RE: SUBMISSION TO SSD-95747716

Thank you for the opportunity to comment on State Significant Development (SSD) application (**SSD-95747716**) for residential development with infill affordable housing at 8A, 14 and 16 Buckingham Road, Killara.

Ku-ring-gai Council's objection to SSD-95747716 at 8A, 14 and 16 Buckingham Road, Killara.

Figure 2: site plan showing current proposal under SSD-95747716

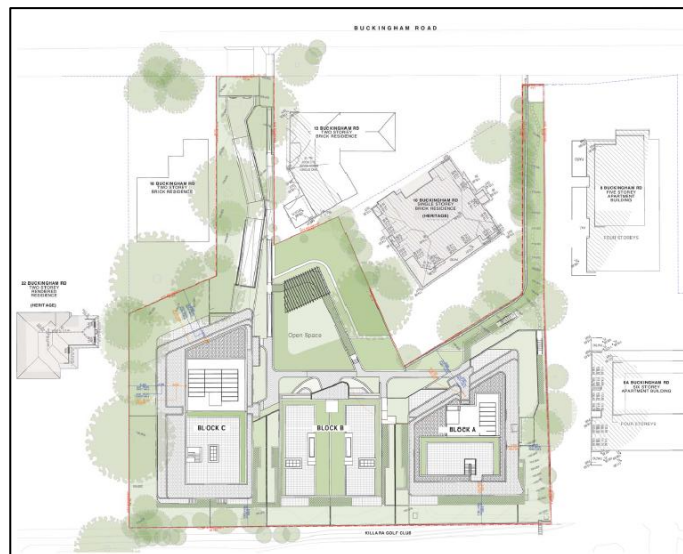
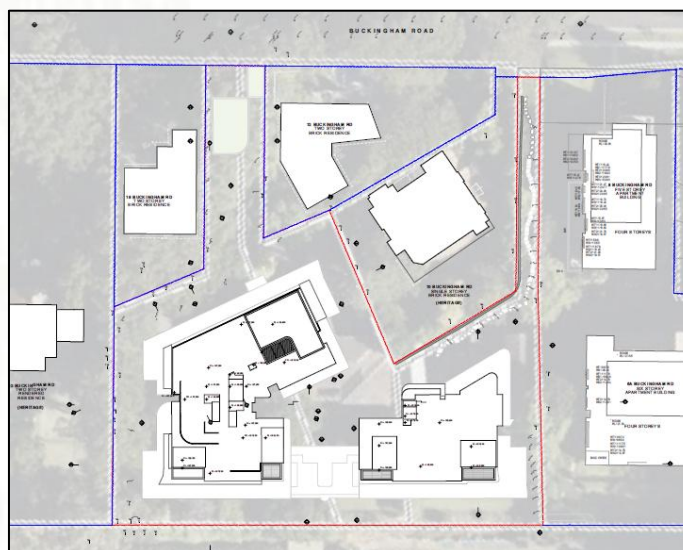
The current proposal is significantly different than previously submitted, as shown within **Figures 1 and 2**. However, as outlined below Council raises concern that the current proposal not be supported.

Figure 3 showing impact areas from proposal

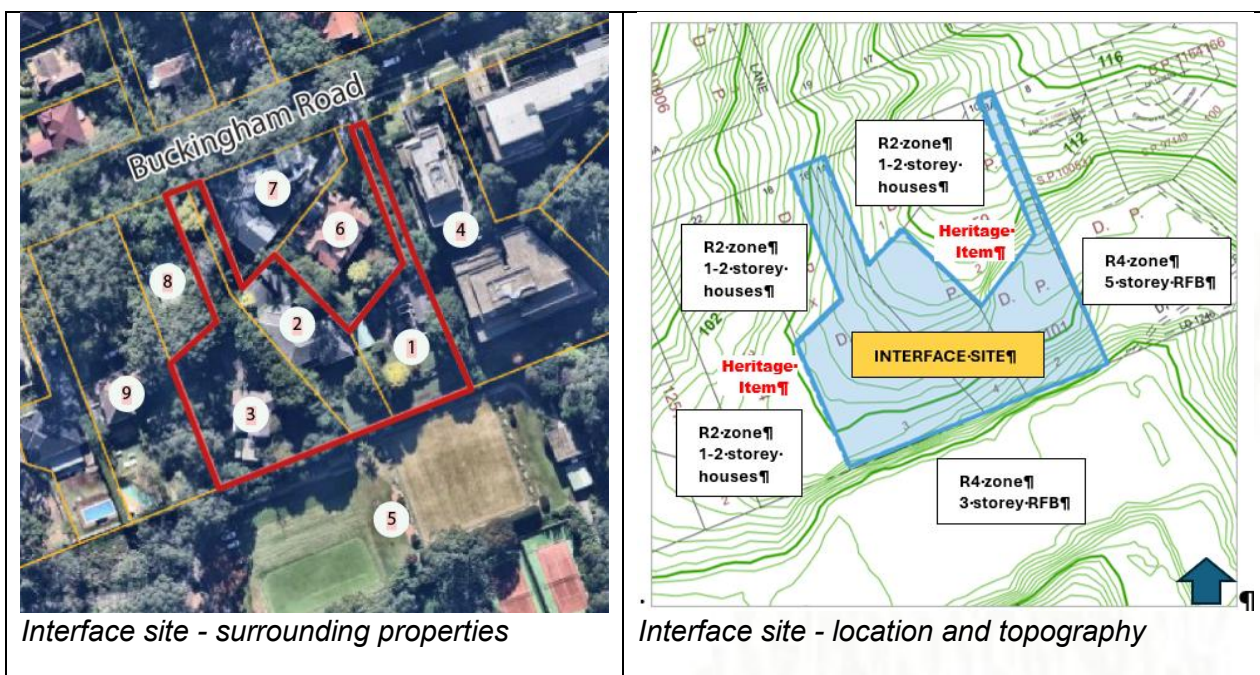
The planning proposal process involved multiple amendments to address the fact that this site was considered an interface site and therefore had high potential for unacceptable impacts to the surrounding dwellings and to the local character:

- 5-storey R4 High Density Residential land to its east - at (4) in below diagram;
- 3-storey R4 High Density Residential land on the Killara Golf Club land to its south - at (5) in below diagram; and
- 2-storey R2 Low Density Residential land to its west and north including 2 Heritage Items to its north and east - 10 and 22 Buckingham Rd, at (6) and (9) in below diagram; and 2 other adjacent single dwellings – 12 and 18 Buckingham Rd, at (7) and (8) in below diagram.

Figure 9: plan showing existing (grey) and proposed (pink) shadow areas

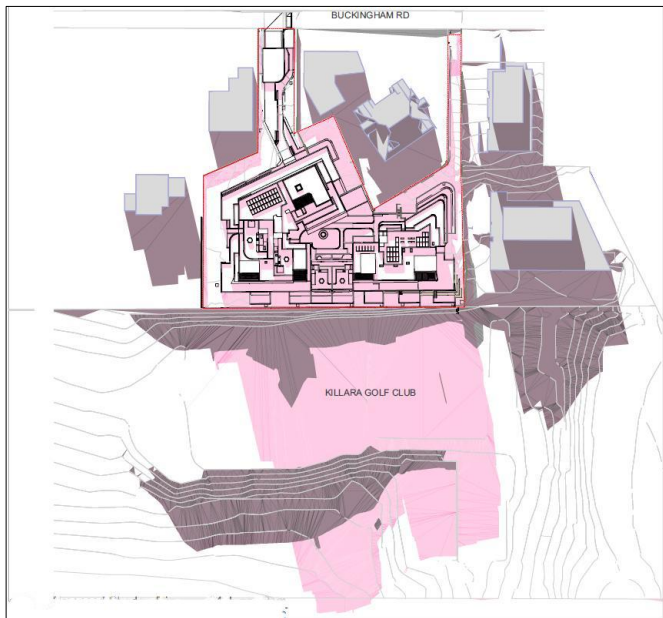
- Incorrect diagram at Figure 46 EIS showing future massing of surrounding sites on R2 low Density Residential land which have heights limited to 9.5m under the low and Mid-rise SEPP amendments.

Figure 10: plan showing drainage lines coloured red

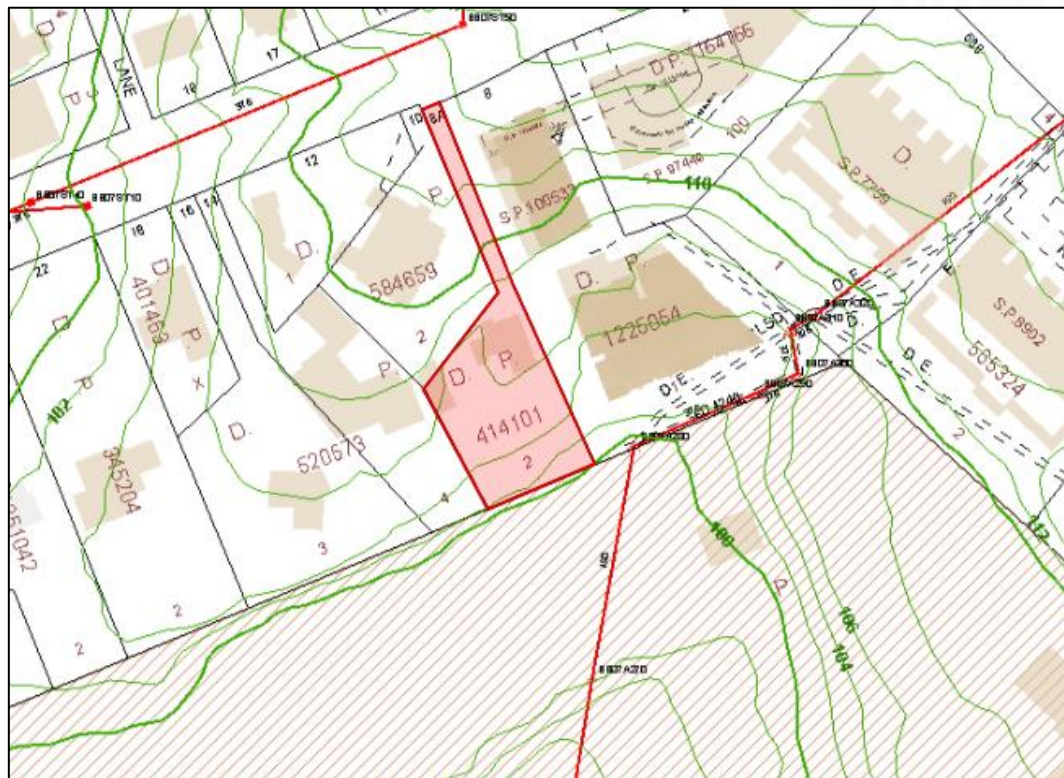
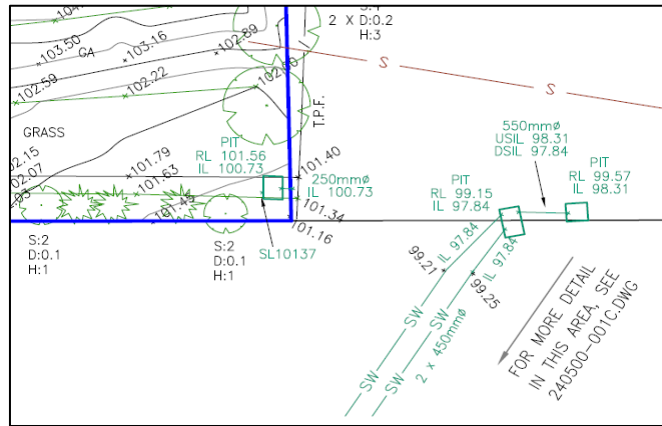
According to Council's mapping system, an existing Council trunk drainage infrastructure traverses the rear of No.8 Buckingham Road containing a 375mm diameter pipe. The pipeline then diverts across the rear onto the Killara Golf Course via a 450mm diameter pipeline towards the natural watercourse.

The design shows a combined detention and retention tank of 100.875m³ and 20,520L respectively located at the rear of the site. The overflow from the detention system is directed to the existing stormwater pit which is assumed to be connecting to Council's drainage network via a new easement over 8 Buckingham Road. The sizing of the detention system complies with Part 24C.5 and Council's On-site Detention Calculation Sheet within the Council 'Technical Guideline for Water Management'. A high-level overflow from the OSD of 300mm diameter to the point of discharge is proposed, which is greater than the existing 250mm pipe within the easement to which connection is proposed.

Figure 12: plan showing areas impacted by flooding

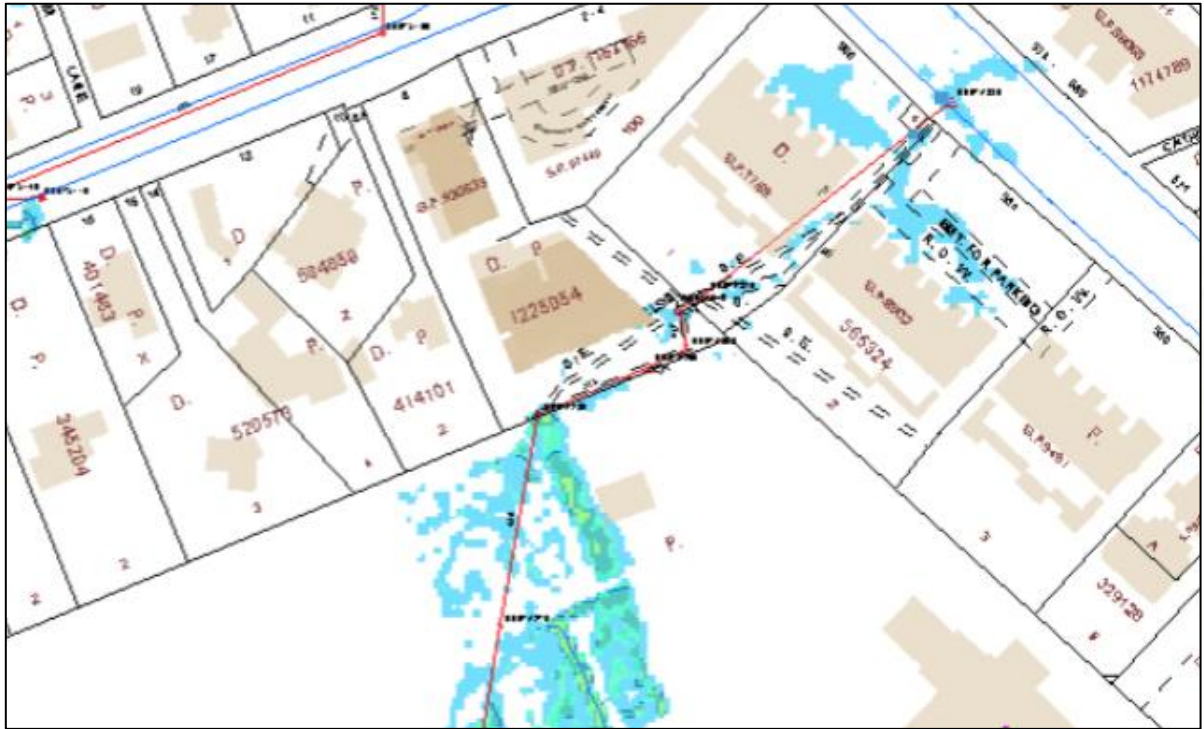
6. The neighbouring properties at 8 Buckingham Road and 556 Pacific Highway are subject to flooding. Therefore, this development must ensure it does not negatively impact the flooding conditions of adjacent properties. Furthermore, no overland flow path was shown on the drainage plan, nor any data showing the velocity and depth of this overland flow.

7. A flood study report prepared by a suitably qualified hydraulic engineer is to be submitted to Council for the 1% AEP design storm to determine the extent of the flow path and freeboard requirements. The Applicant must refer to Part 24 of the Ku-ring-gai DCP which provides a comprehensive outline of what must be considered, demonstrated and submitted with a DA proposal in respect to proposed development adjacent to, or over, a drainage system. All relevant information pertinent to the proposal described in Ku-ring-gai DCP Part 24 shall be submitted to allow an informed assessment.

Figure 17: plans showing location of bin areas

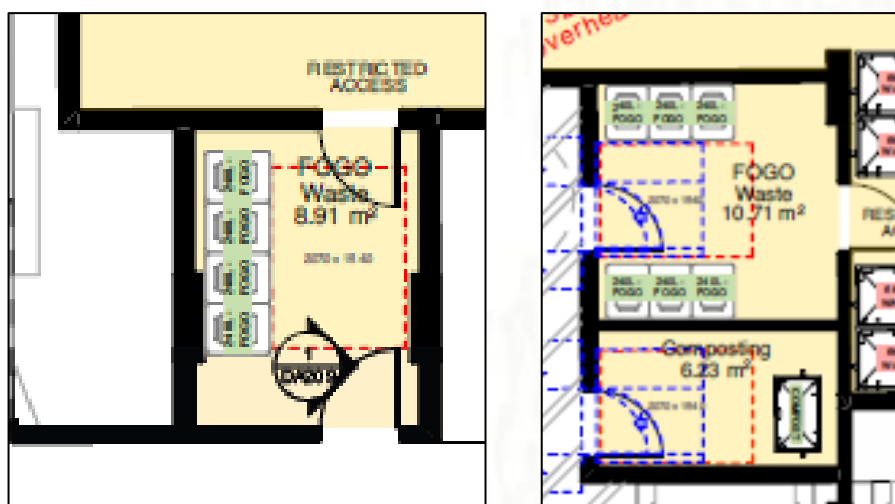
- Allowance for the introduction of FO/FOGO service has been provided with regard to bin numbers and storage. 10 x 240L has been provided in two separate room in the basement.

- Residents carting FO to the basement bin room will reduce resource recover and is not best practice especially when all other bins are accessed on each floor. This is contrary to Objective 25A.1 (1)
- A bin room needs to be provided on each floor that will contain the waste chute, FO bin, Recycling and paper bins. This room is to be mechanical ventilated with floor waste to Sydney water.

- A revised bin room layout needs to be provided to indicate all bins can fit in a bin room on each floor.
- Details of the composting room need to be provided and how it is to be used and what equipment is proposed.

Figure 18: plans showing service bay and manoeuvring

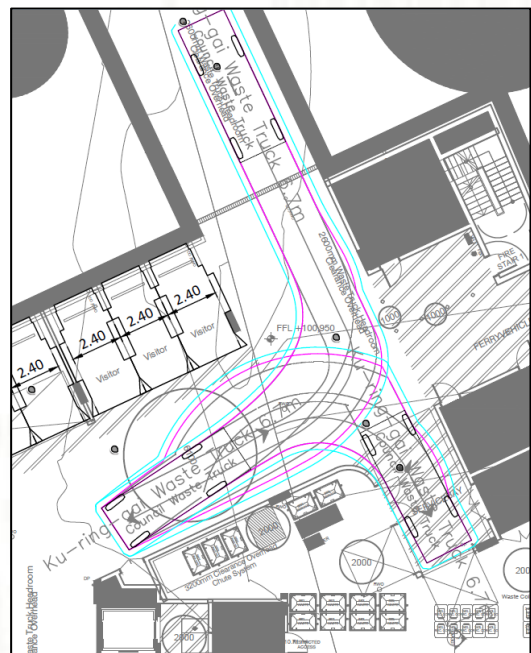
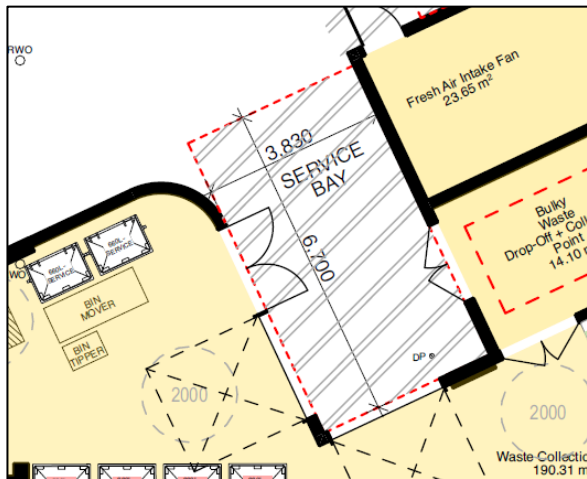
- An adequate loading bay has been provided for Councils small 6.7m length waste truck.
- A rear roller door is provided to allow access and bin carting. This roller door needs to be min 2m wide.
- The traffic management plan indicated Council waste vehicle can access the site in a forward in / out movement.

Figure 20: plan showing head heights at basement entries

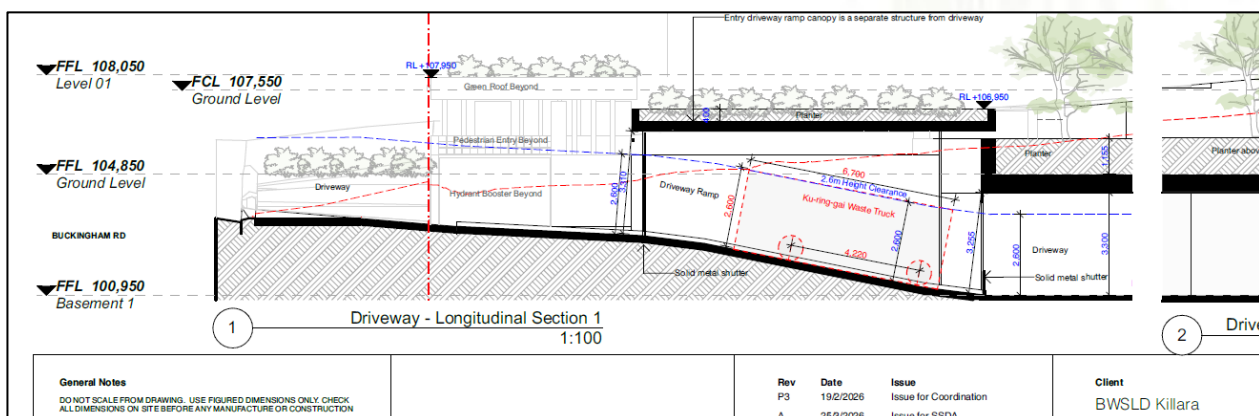
Recommended action: Confirmation of basement ceiling fixture heights needs to be provided

Figure 21: plan showing bin rooms for each residential floor level

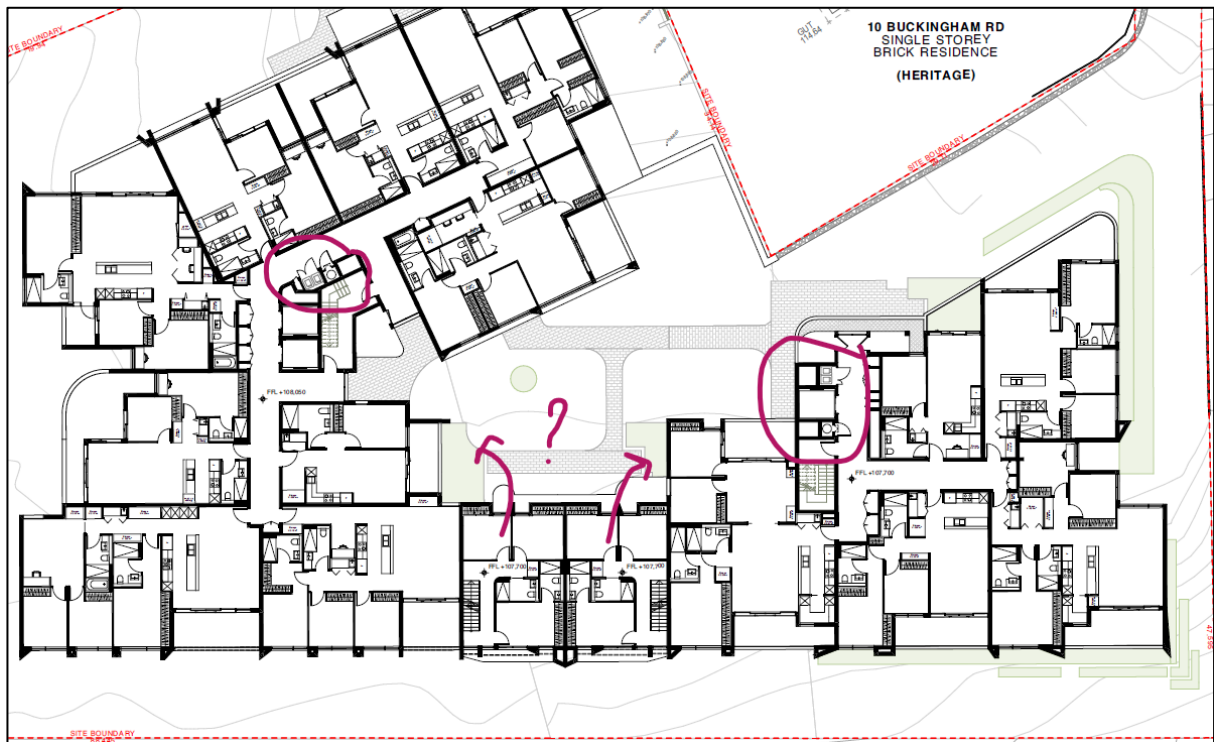
- A waste chute -open to the corridor is provided on each floor – 1 in Building A and 1 in Building C.
- A cupboard is provided for 2 x 240L bins on each floor in each building core.
- A waste room on each floor is a more practical way for residents to access the bins and assist cleaners maintain the areas.
- Each floor waste cupboard/ room needs to include a waste Chute/ container recycling and paper recycling **in addition to a FO bin**. – so, the equivalent space for 3 bins plus chute needs to be provided.
- Unknown door style are shown on the bin cupboard. It is unclear that both bins can be accessed via the one door.
- No FO bins are provided on each floor.
- It is unclear how Building B – 2 units- access the waste infrastructure.

- a) A FO bin needs to be included within each bin room on each floor.
- b) Resize the bins rooms on each floor for three-day capacity and bin numbers.
- c) Provide a waste room instead of a cupboard on each floor. This is to have mechanical ventilation and floor waste to sewer.
- d) Confirmation of Building B access to waste infrastructure.

Figure 23: plan showing Building A Chute area

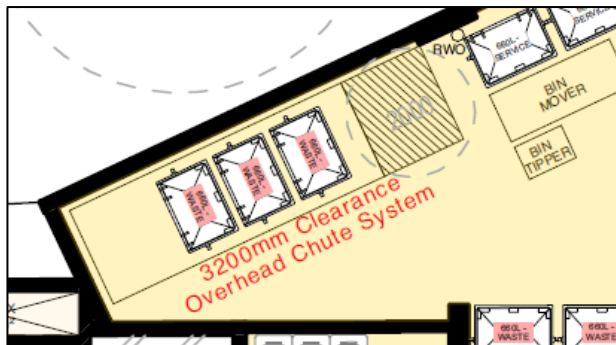
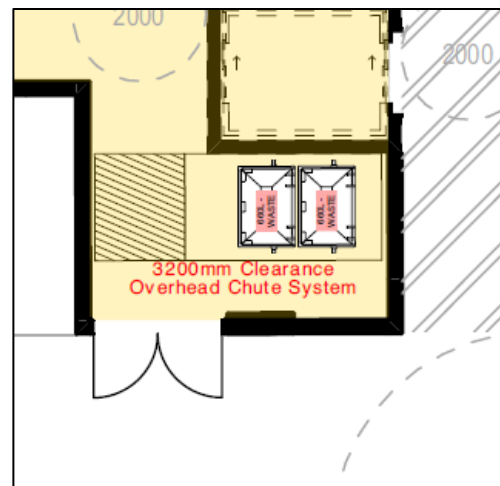
- The chute system is not set up for a linear track system, as described in the Waste plan.
- There are no tracks on the other side of the bin for when it moves.

Figure 25: plan showing bulky waste drop-off area

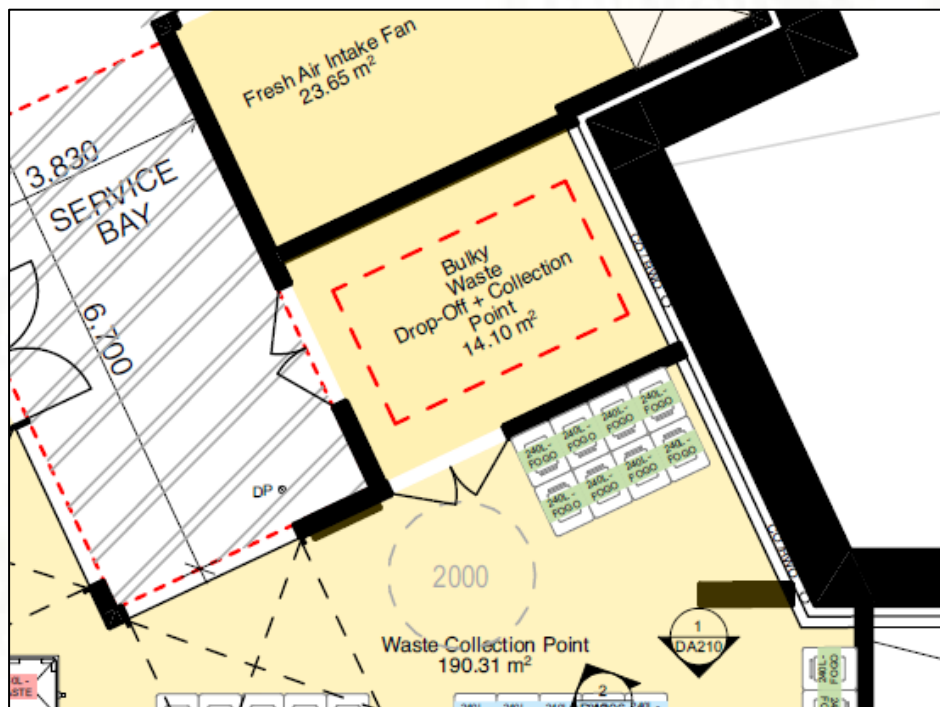
- Bulky waste area meets the DCP requirements.
- The DCP nominates a separate collection point on the driveway, but this is not suitable for this scale development due to the quantity of waste likely to be presented.
- Bulky waste is collected by a HRV waste collection truck.

- a) A Bulky waste collection must provide direct access from a designated bulky waste holding area and accessible by a HRV waste truck (as per AS 2890.2).
